Access Compliance Report

Public Rights-of-Way

Intersection ID: 49394	Main Street: BENGALI_CR	Cross Street: ROMANA_RED_LN	Location: SE
ADA ID: A8728C650B9B	Ramp Type: PerpDiag	Initial Pass/Fail: Pass	Overall Compliance: No
		Severity Score: 0

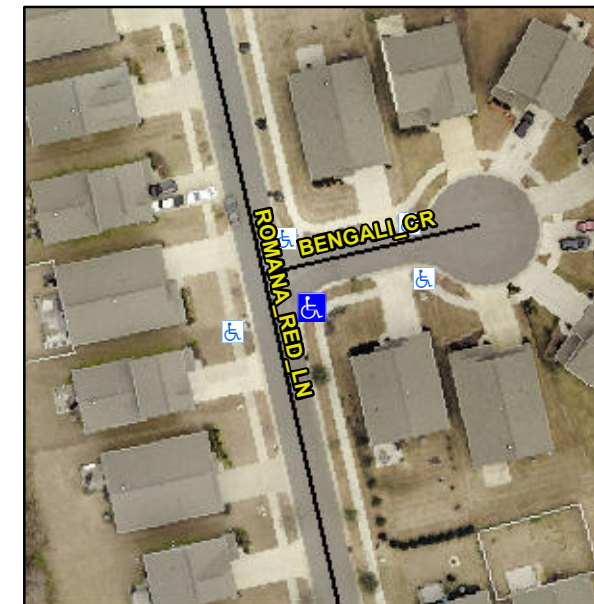
Not Found, R304.2.2-Perp, R304.3.2-Para, R305.2

Compliance	Description	Data	Compliance	Description	Data
N/A	Ramp Length (in)	72.0	Yes	Ramp Slope (%)	8.1
Yes	Ramp Width (in)	48.0	Yes	Ramp XSlope (%)	1.3
N/A	Flare Type LT	Sloped	N/A	Flare Type RT	N/A
N/A	Flare Slope LT (%)	5.5	N/A	Flare Slope RT (%)	11.0
N/A	Flare Traversable LT?	No	N/A	Flare Traversable RT?	No
Yes	Landing Length (in)	60.0	Yes	DWS Provided?	Yes
Yes	Landing Width (in)	52.0	Yes	DWS Contrast?	Yes
No	Landing Slope (%)	3.2	Yes	DWS Length (in)	24.0
Yes	Landing X Slope (%)	0.7	Yes	DWS Full Width?	Yes
N/A	Landing Curb? (Y/N)	No	No	DWS Offset (in)	7.0
N/A	Shared Landing?	No			
Yes	Gutter Ponding?	No	Yes	Gutter Slope (%)	2.3
Yes	Gutter Lip Ht (in)	0.0	Yes	Gutter X Slope (%)	0.7
N/A	Painted X Walk1?	No	N/A	Painted X Walk2?	No
	X Walk 1 Direction	To N		X Walk 2 Direction	To W
N/A	X Walk 1 Width (in)	N/A	N/A	X Walk 2 Width (in)	N/A
	X Walk 1 Slope (%)	1.4		X Walk 2 Slope (%)	3.5
	X Walk 1 X Slope (%)	0.4		X Walk 2 X Slope (%)	1.2

Remove & Replace Curb Ramp With Two New Directional Ramps or Equivalent.
